**DEPARTMENT OF TRANSPORTATION
STATE OF GEORGIA**

FILE: STP00-0157-01(009) Upson Talbot **OFFICE:** Engineering Services
 STP00-0000-00(929)
 P.I. Nos.: 333210 and 0000929
 SR 36 Passing Lanes & Bridge over Flint River **DATE:** May 26, 2009

SUBJECT: IMPLEMENTATION OF VALUE ENGINEERING STUDY ALTERNATIVES

SUBJECT **Value Engineering Study Responses**

STP00-0000-00(929)
EXISTING ALIGNMENT
RADIUS OF HORIZONTAL CURVATURE

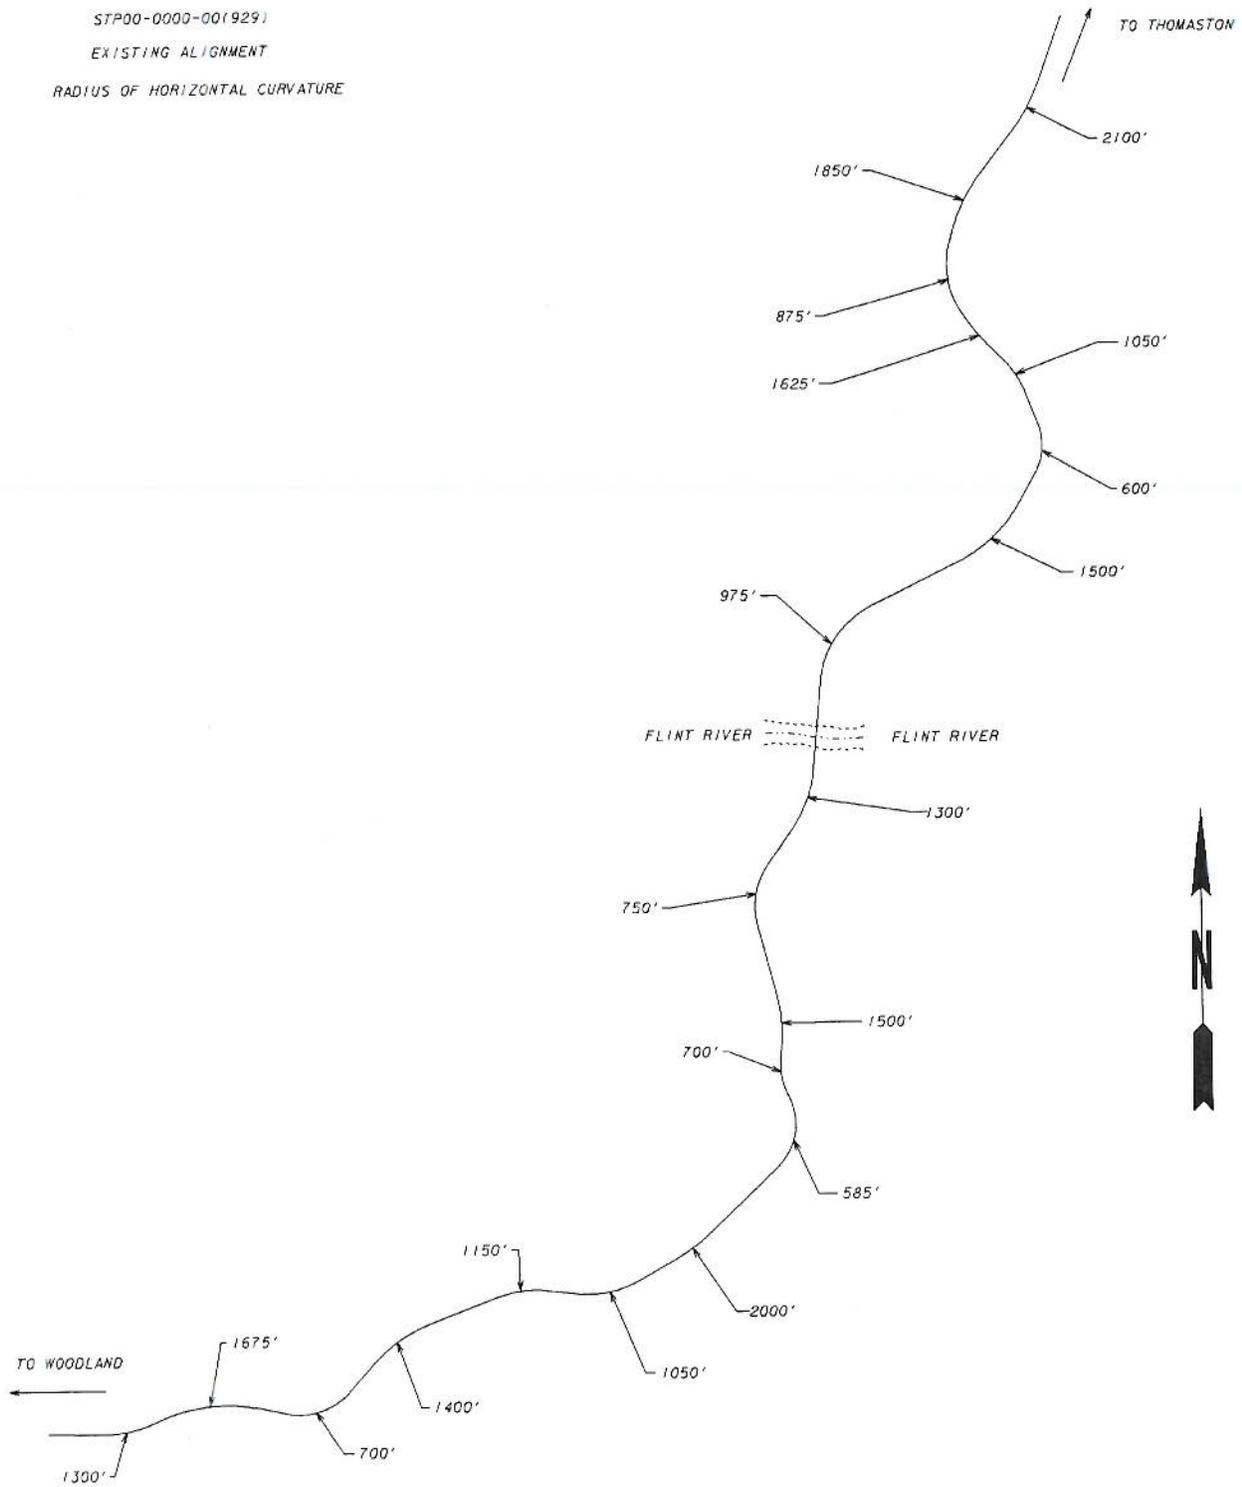
The second issue is with the horizontal geometry. This project has 7 horizontal curves less than 1050 ft. Sight distance becomes a major issue in those areas where the radius of curvature is less than 1050 ft. The existing alignment in Talbot County has many back to back S curves with less than desirable tangent distance between curves. Site 2 in Upson County has multiple broken back curves. Many of the curves with substandard radii are part of a broken back curve situation.

Therefore, we do not recommend maintaining the existing alignment if we proceed with this project.
